# Access Compliance Report

## Public Rights-of-Way

Intersection ID: 28166	Main Street: FLAT_CREEK_DR	Cross Street: WAGON WHEEL_CT	Location: NW
ADA ID: 37476DFE7434	Ramp Type: BlendTrans1	Initial Pass/Fail: Pass	Overall Compliance: No
Severity Score: 15			
Codes/Mitigation Info/Possible Solution		Field Measurements/Component Compliance

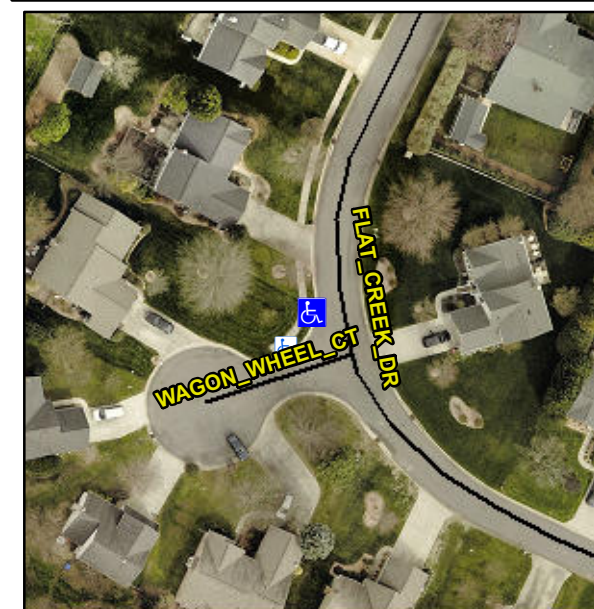
**Not Found, R304.2.1, R304.2.2-Perp, R304.3.2-Para, R305, R304.5.4**

Compliance	Description	Data	Compliance	Description	Data
N/A	Ramp Length (in)	51.5	Yes	BlendTrans Slope (%)	3.5
Yes	Ramp Width (in)	48.0	Yes	BlendTrans XSlope (%)	0.8
N/A	Flare Type LT	Sloped	N/A	Flare Type RT	Sloped
N/A	Flare Slope LT (%)	8.0	N/A	Flare Slope RT (%)	0.4
N/A	Flare Traversable LT?	No	N/A	Flare Traversable RT?	No
No	Landing Length (in)	42.0	No	DWS Provided?	No
Yes	Landing Width (in)	48.0	N/A	DWS Contrast?	No
No	Landing Slope (%)	3.3	N/A	DWS Length (in)	N/A
Yes	Landing X Slope (%)	1.7	N/A	DWS Full Width?	No
N/A	Landing Curb? (Y/N)	No	N/A	DWS Offset (in)	N/A
N/A	Shared Landing?	No			
Yes	Gutter Ponding?	No	No	Gutter Slope (%)	7.5
Yes	Gutter Lip Ht (in)	0.0	Yes	Gutter X Slope (%)	3.8
N/A	Painted X Walk1?	No	N/A	Painted X Walk2?	N/A
	X Walk 1 Direction	To NE		X Walk 2 Direction	N/A
	X Walk 1 Width (in)	N/A		X Walk 2 Width (in)	N/A
	X Walk 1 Slope (%)	3.1		X Walk 2 Slope (%)	N/A
	X Walk 1 X Slope (%)	5.0		X Walk 2 X Slope (%)	N/A

N/A	Ramp inside XWalk1?	N/A	N/A	Ramp inside XWalk2?	N/A
	Road Slope (%)	5.0		Clear Space?	Yes
	Road X Slope (%)	3.1	N/A	Clear Space to XWalk (in)	N/A
Yes	Any Obstructions?	No	Yes	Storm Grate/Utility Hazard?	No
	Obstruction Type			Storm Grate/Utility Type	
		N/A			N/A
			Yes	Surface Condition? (G/P)	Good
			No	Curb Slope (%)	19.3

**Remove & Replace Curb Ramp With Two New Directional Ramps or Equivalent. Remove & Replace Gutter.**
